RPRC RETURN LETTER

Application Number: 2021-0721

Street Location: 9 Quaker Meeting House Road

RE: Lazar Residence – 9 Quaker Meeting House Road – TaxID: 108.03-1-18

CURB DRIVEWAY EDGE
SCALE: 3/4" = 1'-0"
9
D-1

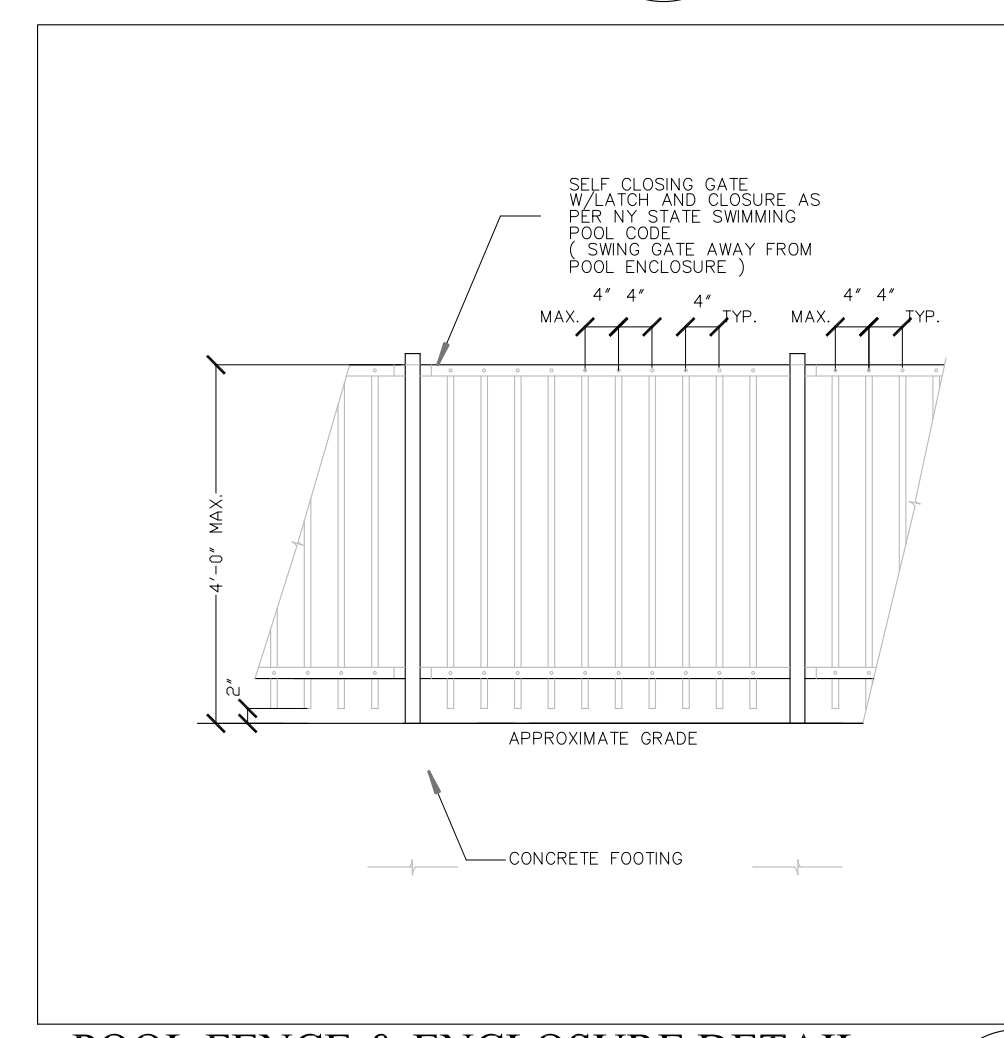
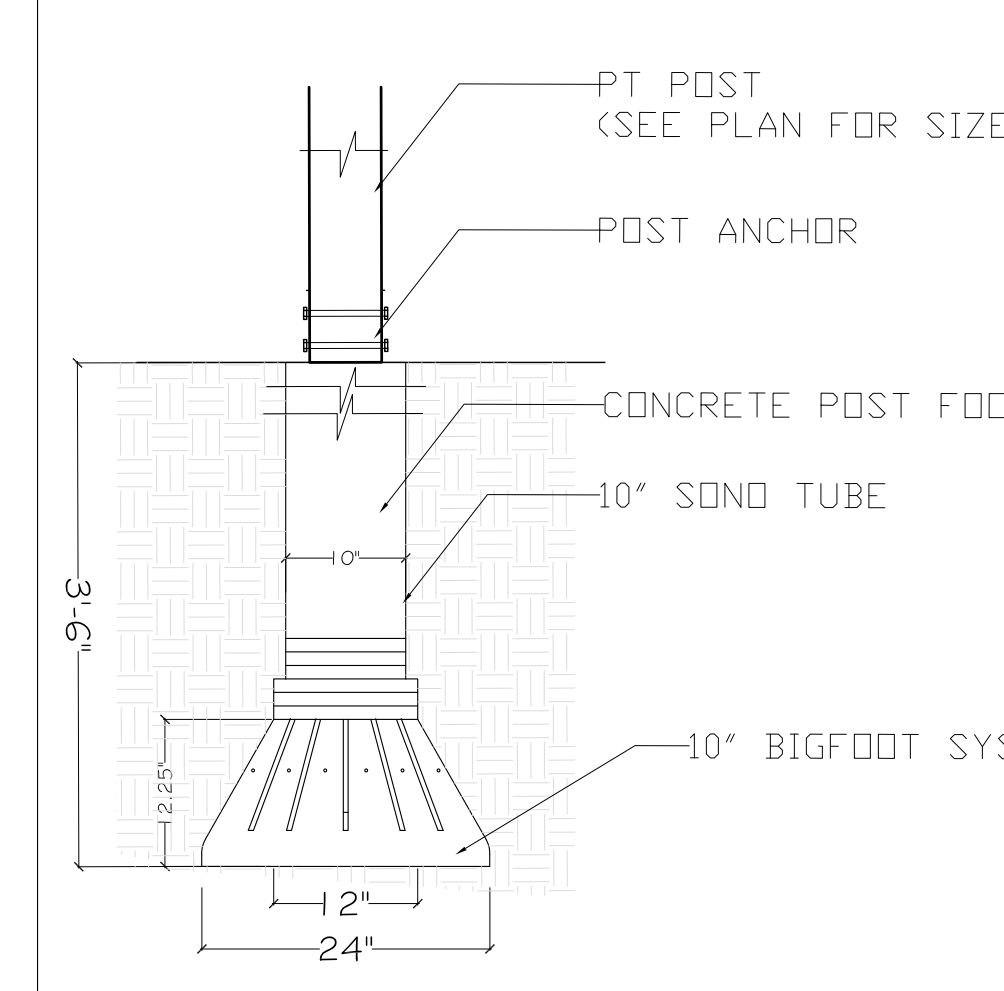
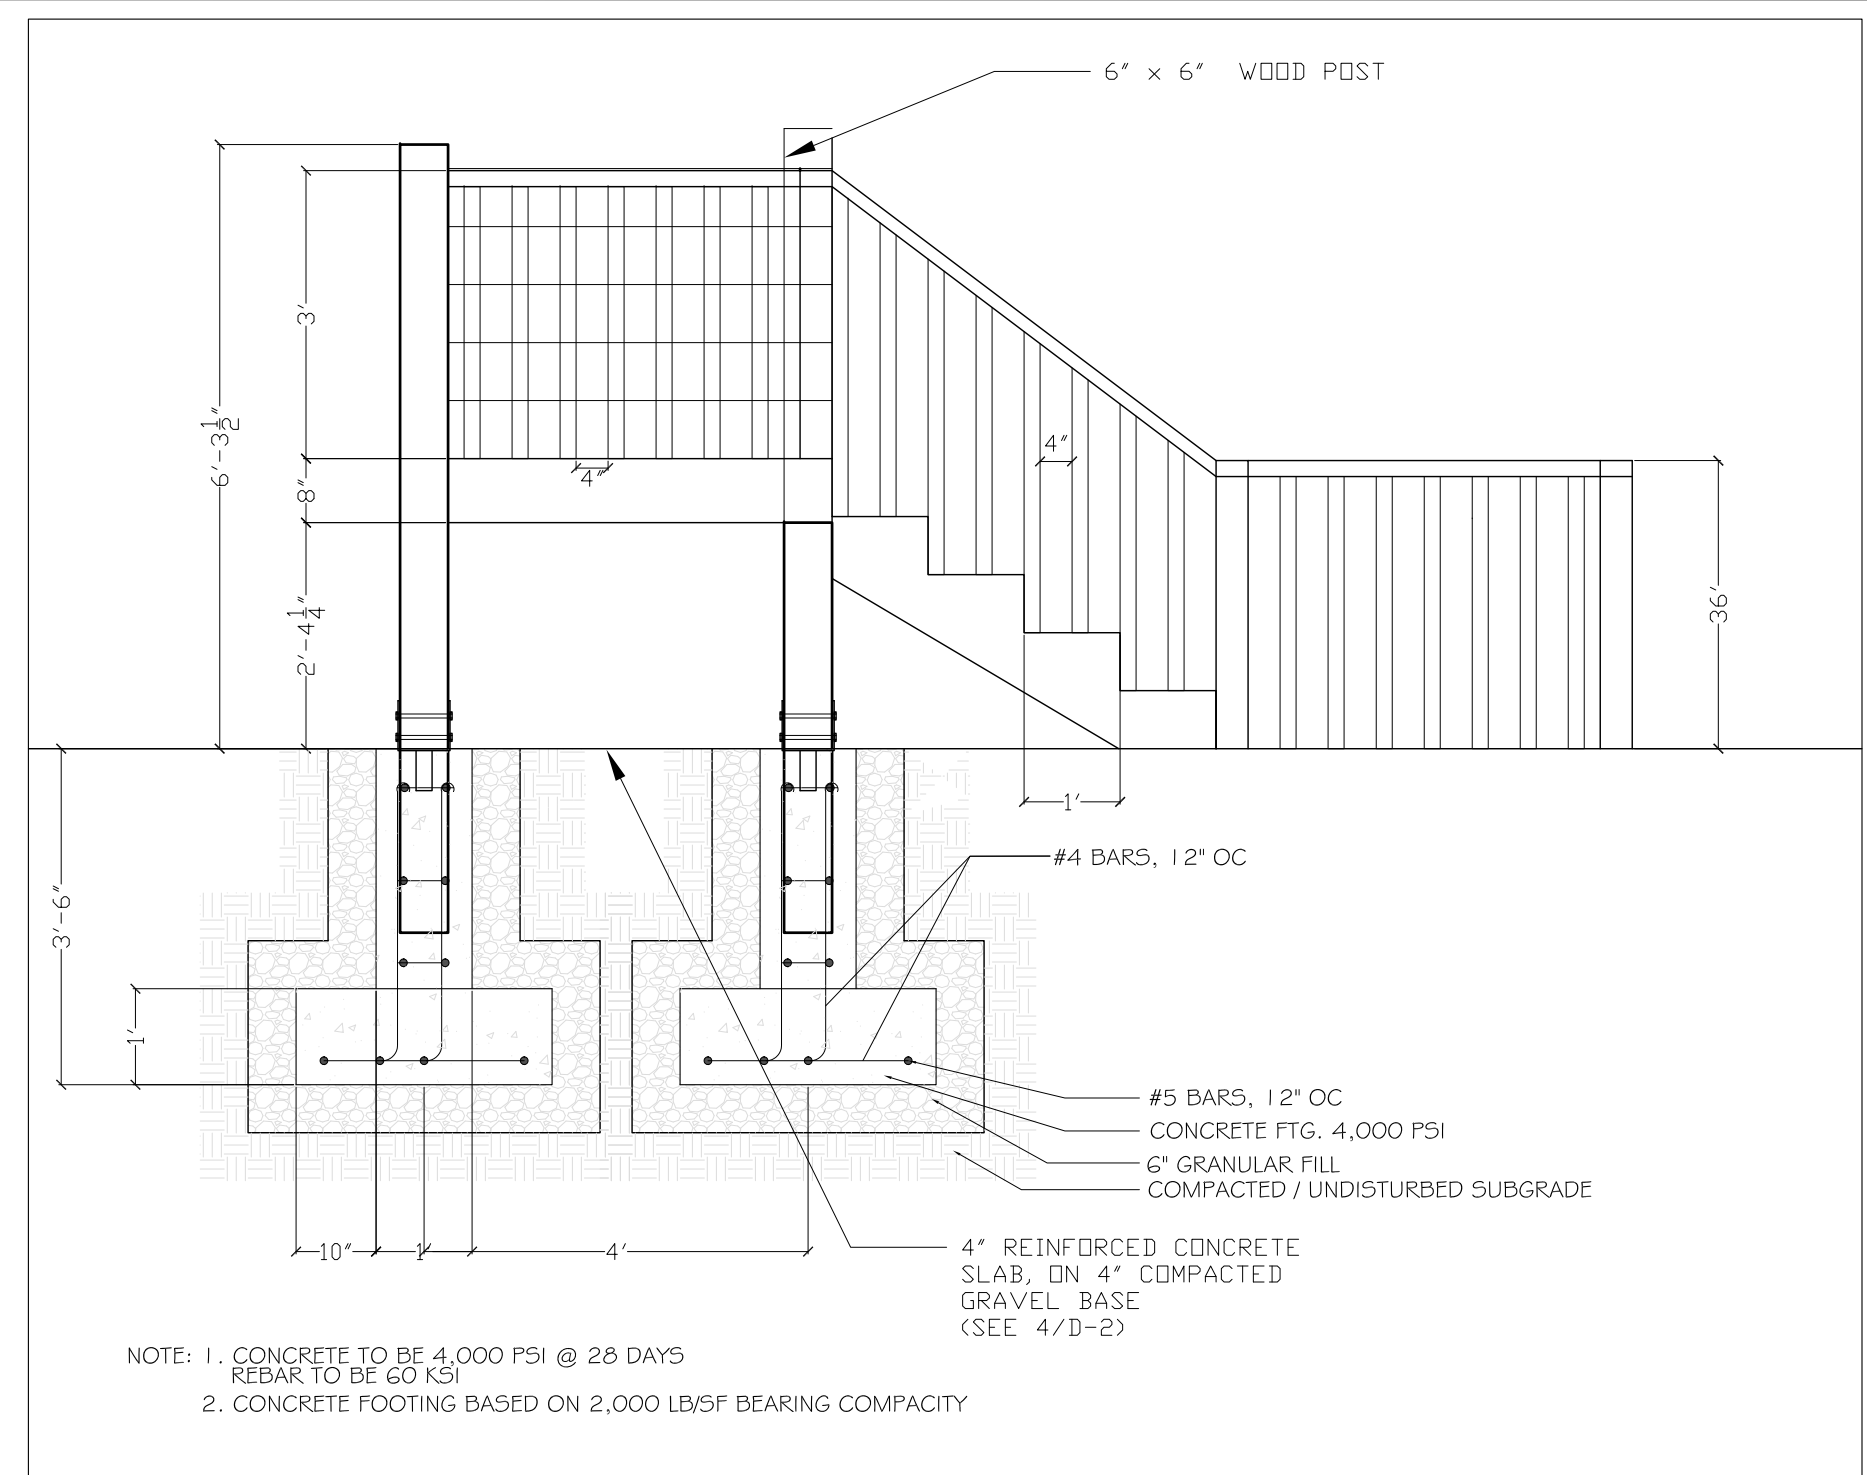
- The project plans should include drains and piping required to collect the runoff and discharge to the stormwater treatment system.
- The plans should provide construction details for the drainage system, retaining walls, patio, decorative driveway bands.

9. The plans should provide construction details for the drainage system, retaining walls, patio, decorative driveway bands.

Response: All construction details have been provided for the proposed work on sheet D-1. Drainage system details have been provided on engineering plans by Ahneman Kirby, LLC.
